Access Compliance Report

Public Rights-of-Way

(Curb Ramps)

Intersection ID: 9785	Main Street: BROWNS_AV	Cross Street: TUCKASEEGEE_RD	Location: NW
ADA ID: 5E495CCA06F5	Ramp Type: BlendTrans2	Initial Pass/Fail: Fail	Overall Compliance: No
		Severity Score: 8.75

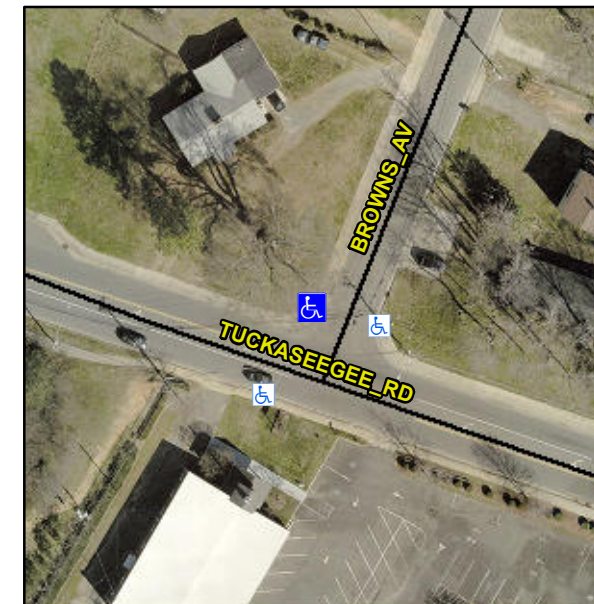
Not Found, R304.5.1

Compliance	Description	Data	Compliance	Description	Data
N/A	Ramp Length (in)	73.0	Yes	BlendTrans Slope (%)	3.2
No	Ramp Width (in)	46.5	Yes	BlendTrans XSlope (%)	0.5
N/A	Flare Type LT	N/A	N/A	Flare Type RT	N/A
N/A	Flare Slope LT (%)	N/A	N/A	Flare Slope RT (%)	N/A
N/A	Flare Traversable LT?	N/A	N/A	Flare Traversable RT?	N/A
N/A	Landing Length (in)	N/A	N/A	DWS Provided?	N/A
N/A	Landing Width (in)	N/A	N/A	DWS Contrast?	N/A
N/A	Landing Slope (%)	N/A	N/A	DWS Length (in)	N/A
N/A	Landing X Slope (%)	N/A	N/A	DWS Full Width?	N/A
N/A	Landing Curb? (Y/N)	N/A	N/A	DWS Offset (in)	N/A
N/A	Shared Landing?	N/A			
N/A	Gutter Ponding?	N/A	N/A	Gutter Slope (%)	N/A
N/A	Gutter Lip Ht (in)	N/A	N/A	Gutter X Slope (%)	N/A
N/A	Painted X Walk1?	No	N/A	Painted X Walk2?	No
	X Walk 1 Direction	To SW		X Walk 2 Direction	To SE
	X Walk 1 Width (in)	N/A		X Walk 2 Width (in)	N/A
	X Walk 1 Slope (%)	0.2		X Walk 2 Slope (%)	1.7
	X Walk 1 X Slope (%)	3.4		X Walk 2 X Slope (%)	1.6

N/A	Ramp inside XWalk1?	N/A	N/A	Ramp inside XWalk2?	N/A
	Road Slope (%)	0.5		Clear Space?	N/A
	Road X Slope (%)	1.5	N/A	Clear Space to XWalk (in)	N/A
N/A	Any Obstructions?	N/A	N/A	Storm Grate/Utility Hazard?	N/A
	Obstruction Type			Storm Grate/Utility Type	
		N/A			N/A
			Yes	Surface Condition? (G/P)	Good
			No	Curb Slope (%)	22.9

Remove & Replace Curb Ramp With Two New Directional Ramps or Equivalent.
